**Attachment C: Amendments to Resolution 4786 – City of Kirkland
Shoreline Master Program**

The following text consists of amendments to Resolution #4786 the locally adopted version of the City of Kirkland’s Shoreline Master Program. These amendments have been determined by the Department of Ecology to be included as part of the final approval of the City’s Shoreline Master Program as described in Attachment B (Findings/Conclusions).

Plate 19 – Average Parcel Depth

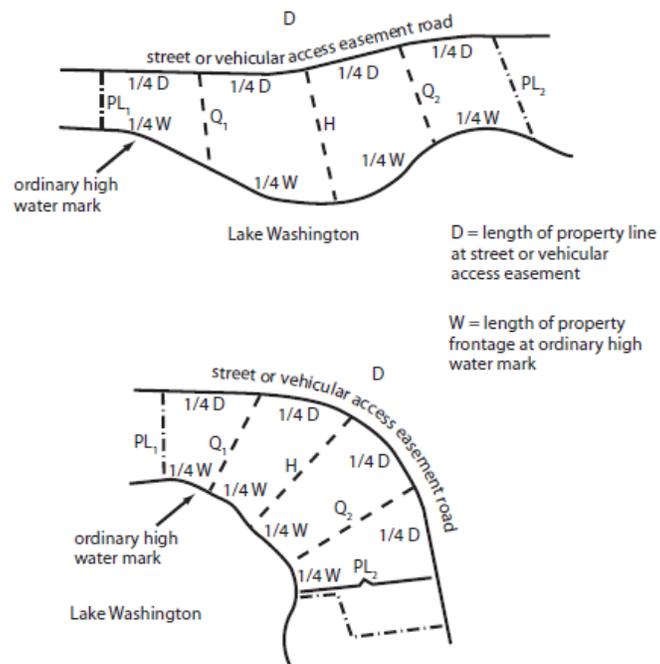
- **Plate 19 - Average Parcel Depth** referenced in 83.80.7 definition of average parcel depth.
- **Plate 41 - Measuring Shoreline Setback** referenced in 83.190.2.b in shoreline setback section.
- **Plate 42 - Maximum Shoreline Walkway Corridor** referenced in Section 83.190.2.d.2 in shoreline setback section.
- **Plate 43 - Options for Shoreline Stabilization Measures** referenced in Section 83.300.5 for submittal of major repair of hard stabilization measures.
- **Plate 44 - Addition to Nonconforming Detached Dwelling Unit** referenced in Section 83.550.5.b.5 in nonconformance section.

Plate 41 – Measuring Shoreline Setback

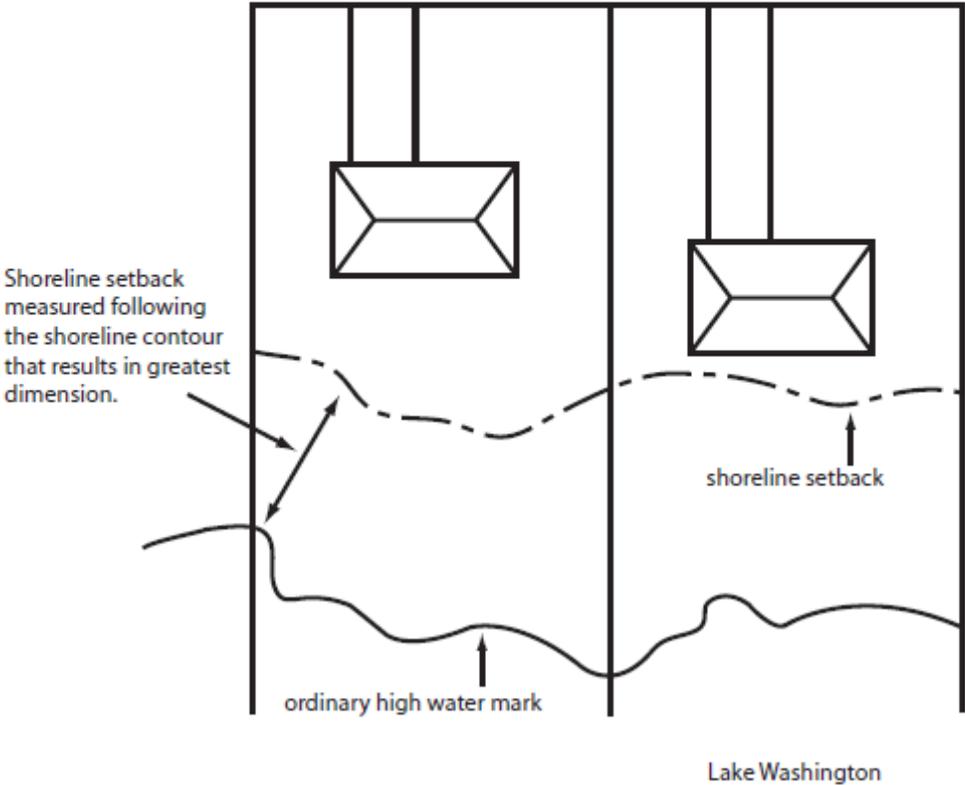
- 1) The shoreline setback shall be measured landward from the OHWM on the horizontal plane and in the direction that results in the greatest dimension from the OHWM (see Plate ~~XX~~ 41).

Plate 42 – Maximum Shoreline Walkway Corridor

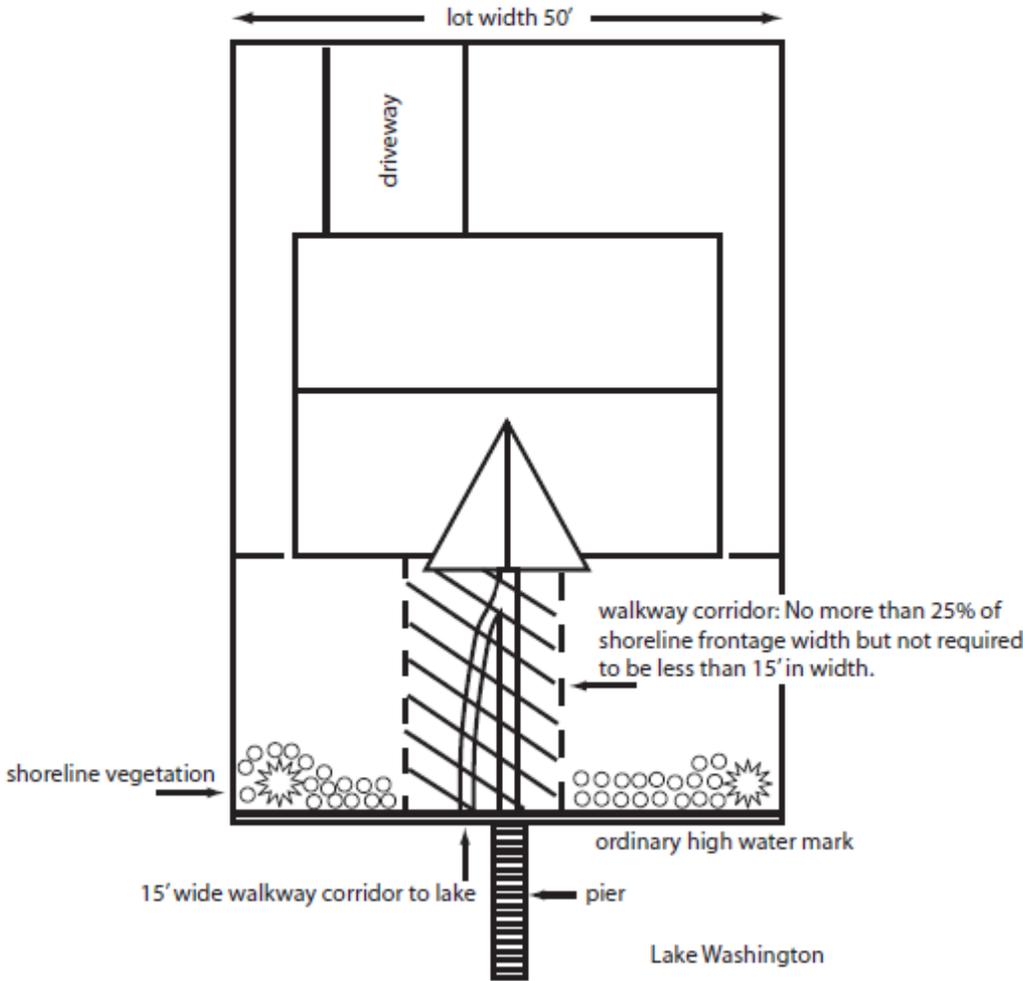
- 1) For public pedestrian access required under KZC 83.420, walkways, benches, and similar features, as approved by the Planning Official.
- 2) For private pedestrian access to the shoreline, walkways within the shoreline setback are permitted, subject to the following standards:
 - a) The maximum width of the walkway corridor area shall be no more than 25 percent of the property’s shoreline frontage, except in no case shall the corridor area required be less than 15 feet in width (see Plate ~~XX~~ 42).

Plate 43 – Options for Shoreline Stabilization Measures (pages 1 of 2)

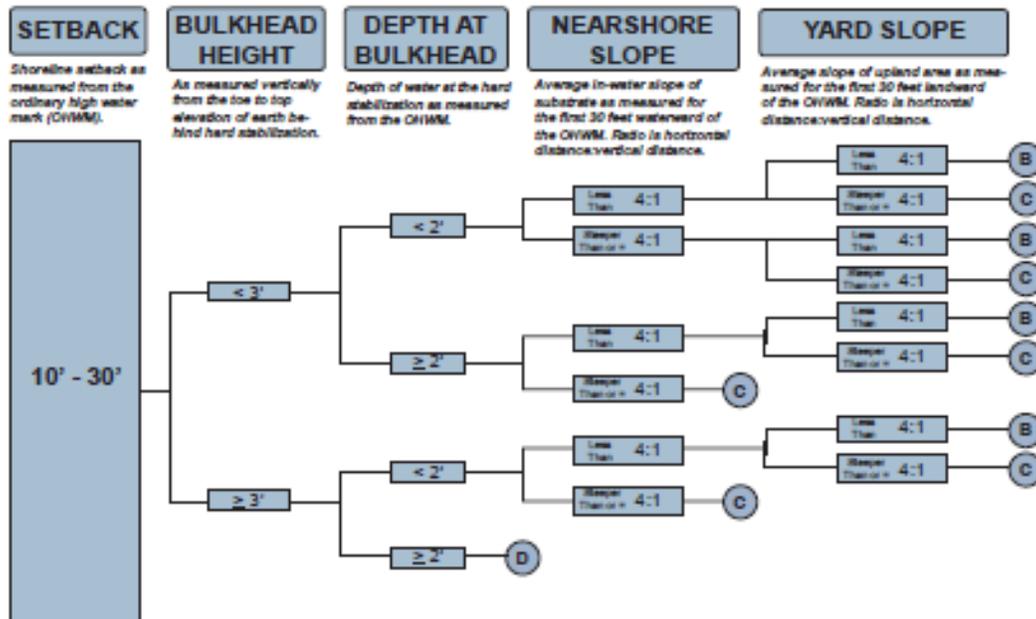
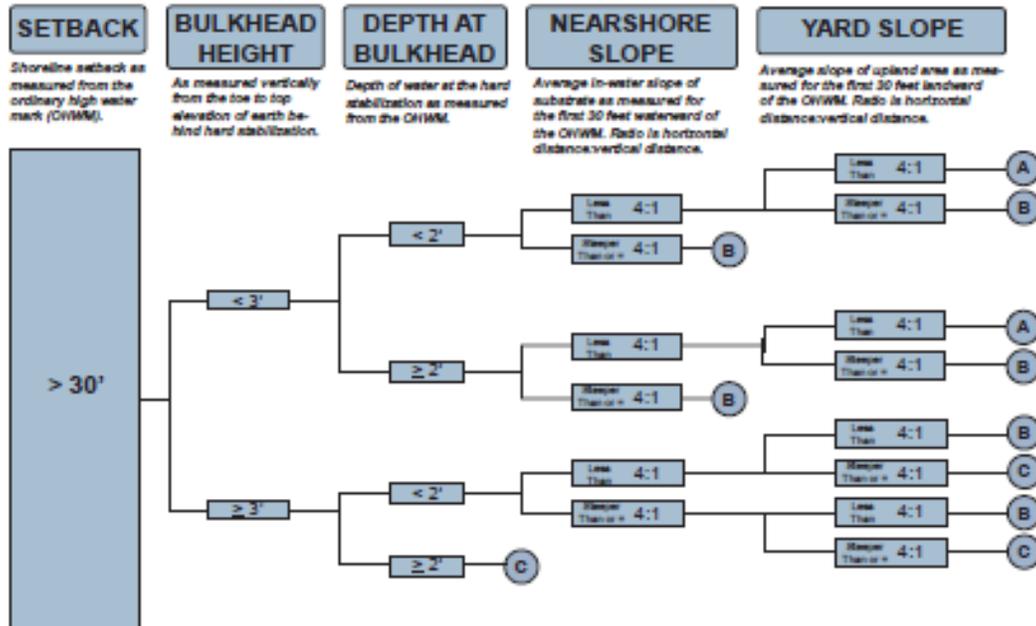
- 1) For a hard structural shoreline stabilization measure, an evaluation of the feasibility of using nonstructural or soft shoreline stabilization measures in lieu of hard structural shoreline stabilization measures. The evaluation shall address the feasibility of implementing options presented in Plate ~~XX~~ 43 based on an assessment of the subject property's characteristics.

- 1) An assessment of the necessity for hard structural stabilization, considering site-specific conditions such as water depth, orientation of the shoreline, wave fetch, and location of the nearest structure. The evaluation shall address the feasibility of implementing options presented in Plate ~~XX~~ 43, given an assessment of the subject property's characteristics.

Plate 44 – Additions to Nonconforming Detached Dwelling Units

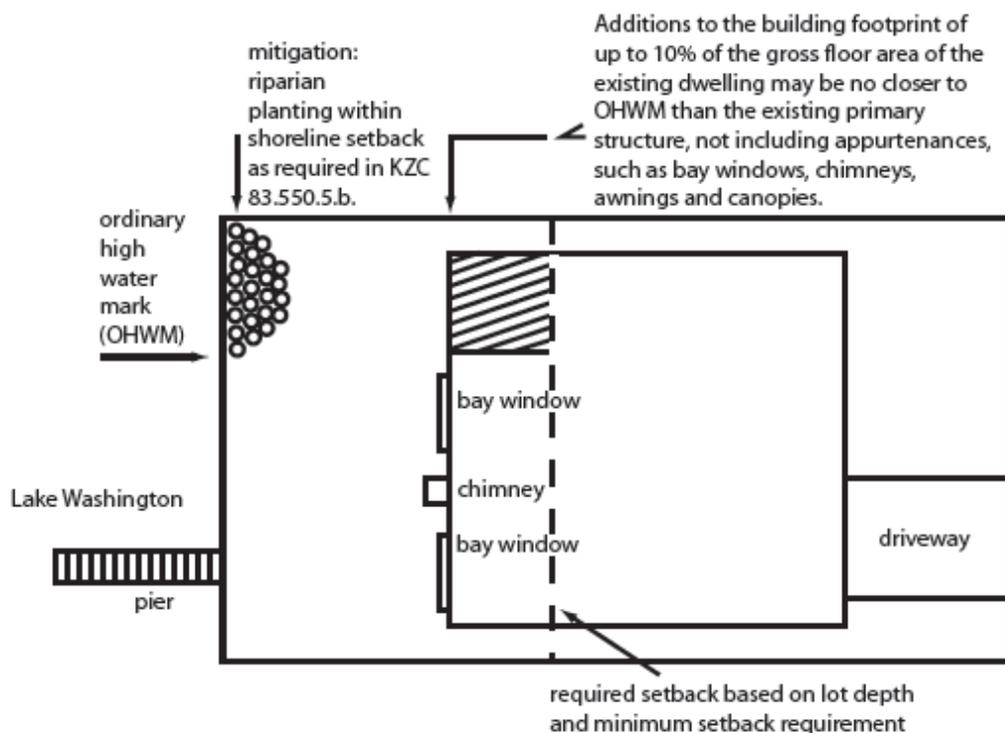
- 5) The enlargement shall not extend further waterward than the existing primary residential structure. For purposes of this subsection, the improvements allowed within the shoreline setback as established in KZC 83.180, such as bay windows, chimneys, greenhouse windows, eaves, cornices, awnings and canopies shall not be used in determining the most waterward location of the building (see Plate ~~XX~~ 44).

- 2) The size of the building footprint shall not be increased and the reconstructed structure shall not extend further waterward than the existing primary residential structure. For purposes of this subsection, the improvements allowed within the shoreline setback as established in KZC 83.180, such as bay windows, chimneys, greenhouse windows, eaves, cornices, awnings and canopies shall not be used in determining the most waterward location of the building (see Plate ~~XX 44~~).

Plate 22 – WD 11 North Property Line Yard and Height of Structure.

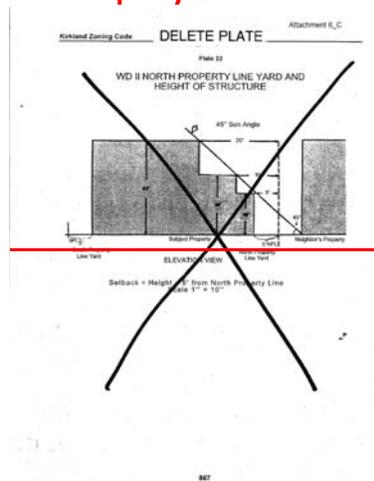
The following plates should not be considered part of the approved SMP:

- **Plate 22** – WD 11 North Property Line Yard and Height of Structure.
- **Plate 27A, 27B, 27C** – Shoreline View Corridor.
- **Plate 28** – North Property Line – Waterfront District (WD) Zones.
